Campaign No. 2021060008 June, 2021

SUBJECT: **Model 907 Sprinter, Model Year 2020**
Check Torque on Front Door Hinge Screws

D72.10-A007-79

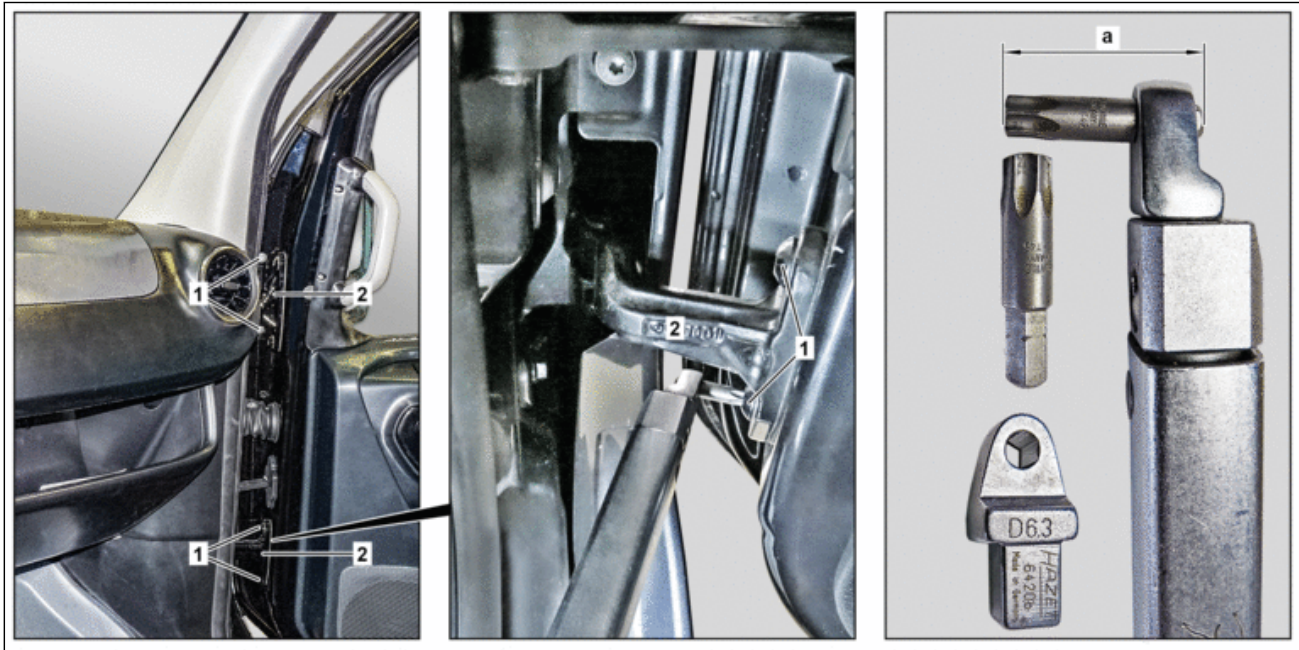
Check threaded connections of hinges (2) on **both** front doors.

Check		
1	Check, whether the vehicle is affected by the measure.	 For authorized Mercedes-Benz service partners, only the entry in the Extended VEGA Application (EVA) system, in the "Current" tab, is decisive. An additional test of the affected vehicles in the workshop information system (WIS) or vehicle list is thereby not necessary.	
2	Fully open each front door.		
3	Check front door for play on screws (1) and hinges (2).  AR	 To do so, move front door e.g. abruptly. If front door exhibits play on the screws (1) or hinges (2), ↓ Adjust front door. If front door does not exhibit any play on the screws (1) or hinges (2), ↓ continue with operation step 4.	AR72.10-D-0550TS
	Tighten threaded connection		
4	Tighten screws (1). Note on calculation of tightening torque when using insertion or socket tools with various effective lengths	If the respective front door does not exhibit any play on the screws (1) or hinges (2).  Use torque wrench attached at low eye-level height. Observe dimension (A).  Screw/bolt, hinge to front door	AH00.00-P-0015-01CW BA72.10-N-1010-01TS

Number	Designation	Model 907
BA72.10-N-1010-01TS	Screw/bolt, hinge to front door	Nm 23
